Council assessment of Clause 4.6 request to vary height of buildings development standard

Visual representation of height offset

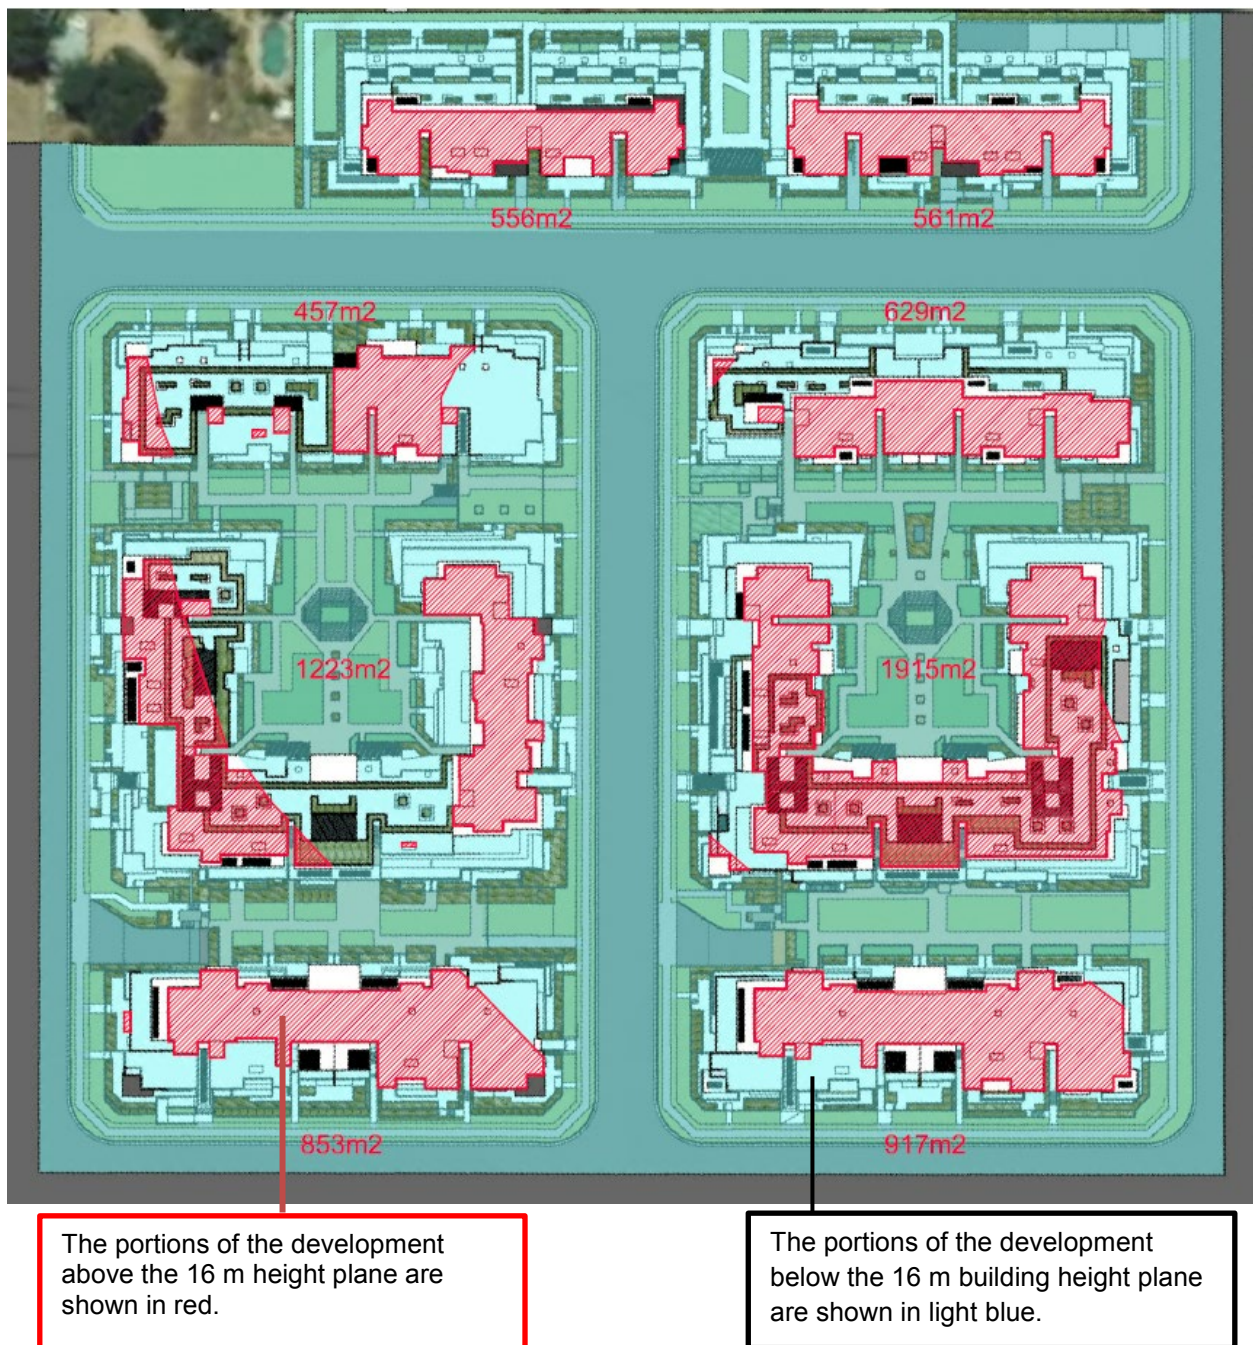
The following figures identify the portions of the building envelopes proposed in JRPP-16-04460 that exceed the 16 m height limit and the portions of the development that are below the height limit of Clause 4.3 Height of Buildings in Appendix 4 Alex Avenue and Riverstone Precinct Plan 2010 of *State Environmental Planning Policy (SEPP) 2006*. The building height is measured from the ground levels created by the new roads.

- The parts of the proposed building envelopes which exceed the height limit relate to the some parts of habitable rooms, rooflines and parapets, and lift and stair overruns to enable access to rooftop communal open space areas and rooftop shade structures.

- The scale of the development is consistent, being 5 storeys across the site.
- The stepped building forms mean that some portions of the buildings are below the 16 m building height limit to compensate for some parts of the buildings and rooftop structures being above the building height limit.

Objectives of Clause 4.3 'Height of buildings'	How the proposal achieves the objective
a. To establish the maximum height of buildings for development on land within the Alex Avenue and Riverstone Precincts.	<p>Although the proposed building envelopes exceed the permissible height by up to 3.02 m to the roofline and 6.52 m to the rooftop lift overrun as measured from the new ground levels, the development provides a development which is consistently a scale of 5 storeys. The development does not achieve an additional residential level.</p> <p>The creation of the new roads and associated civil infrastructure results in new ground levels which are generally lower than the existing ground levels, and the measurements from this new ground level to the roofline and rooftop structures are inflated.</p> <p>The increase in height does not impact on the density, floor area or scale of the development. The additional height simply accommodates the roof line, parapets and rooftop structures, including shade structures and access to rooftop communal open space areas for Buildings A, B, C, D, G and H.</p>

Based on the above assessment, the Clause 4.6 variation request is considered reasonable and well founded. It is recommended for support to allow flexibility in the application of the development standard.
